## New 6" AdvanceDrive Wheels

**OPERATORS:** SlideDriver™ operator models using 6" AdvanceDrive wheels

**DATE:** 09/01/2020

**SUBJECT:** New 6" aluminum AdvanceDrive wheels

Figures 1 and 2 (below) show the differences between old and new AdvancedDrive wheel assemblies.

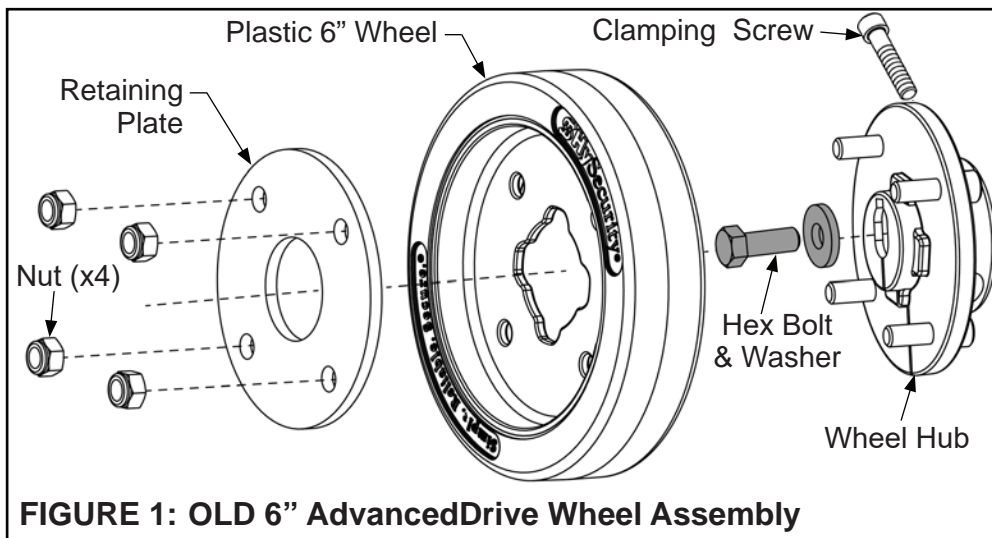
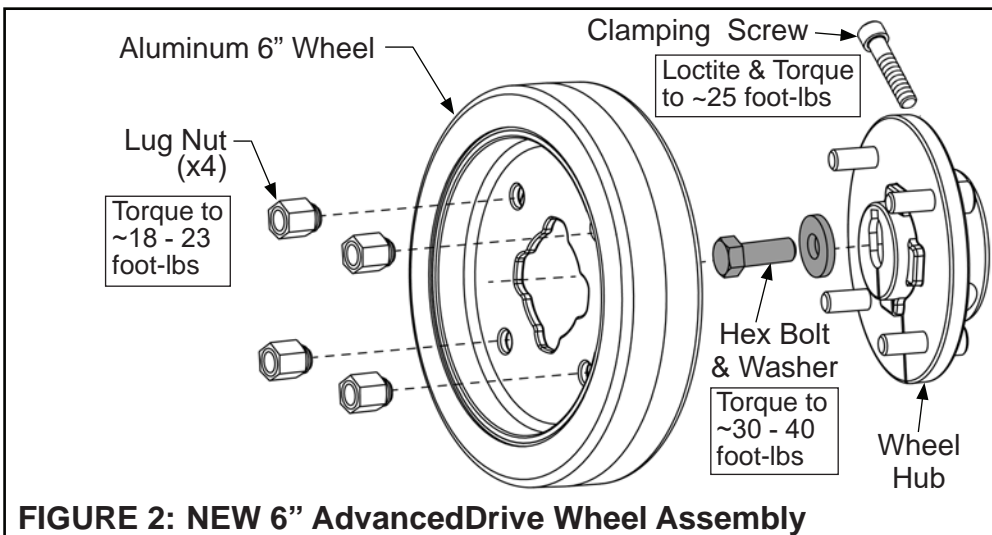
The 6" AdvanceDrive wheels used in SlideDriver models have been replaced with new wheels that do not require a metal retaining plate. The 8" AdvancedDrive and 8" XtremeDrive wheels used in some models will be updated similarly at a later date.

Simpler disassembly during maintenance.

**NOTE:** New wheels are compatible with the hubs from plastic wheels but require new nuts. If replacing older aluminum wheels they will need a kit with a new hub.
